P-14100

S4304

SYMBOL OF QUALITY AN ISO 9001 COMPANY	JINDAL ALUMINIUM LTD.		
	BANGALORE-560073 (INDIA)		
	1. ALL DIMENSIONS ARE IN mm. 2. ROUND OFF ALL SHARP CORNERS WITH 0.40 mm. 3. TOLERANCES WILL BE AS PER IS:3965-1981 UNLESS OTHERWISE SPECIFIED		
PARTY'S NAME		BHORUKA FABCONS PVT. LTD., MYSORE	
PARTY'S DRAWING No.		BFPL-DWG094 REV. A	
ALLOY & TEMPER		6063 T6	
DESCRIPTION		HEAT SINK SECTION

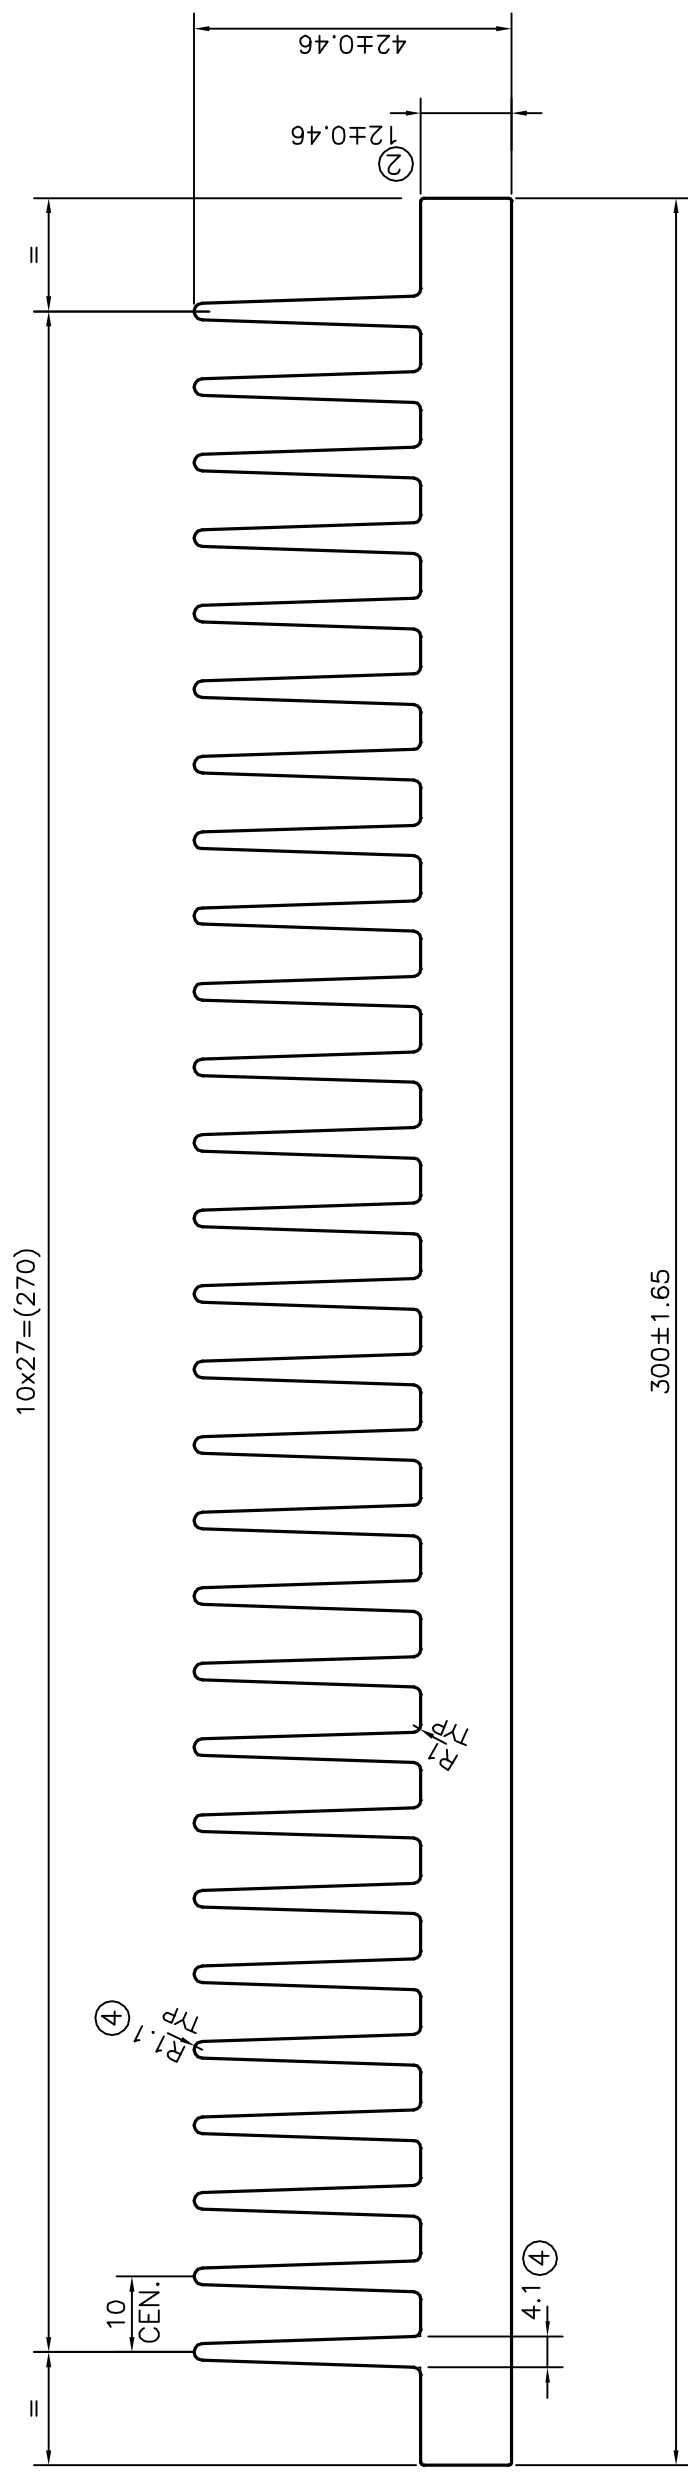
ISSUE-2:-

BASE THICKNESS CHANGED FROM 10 mm TO 12 mm
WEIGHT ALSO CHANGED FROM 14.761 kg/m TO 15.932 kg/m
ON DATED 07/07/2015

ISSUE-3:-

FIN HEIGHT CHANGED FROM 40mm TO 42 mm
WEIGHT ALSO CHANGED FROM 15.932 kg/m TO 16.234 kg/m

ISSUE-4:-

DIMENSION CHANGED FROM 3.94 TO 4.1 & FIN RADIUS CHANGED FROM RADIUS 1 TO 1.10 mm
WEIGHT ALSO CHANGED FROM 16.234 kg/m TO 16.777 kg/m
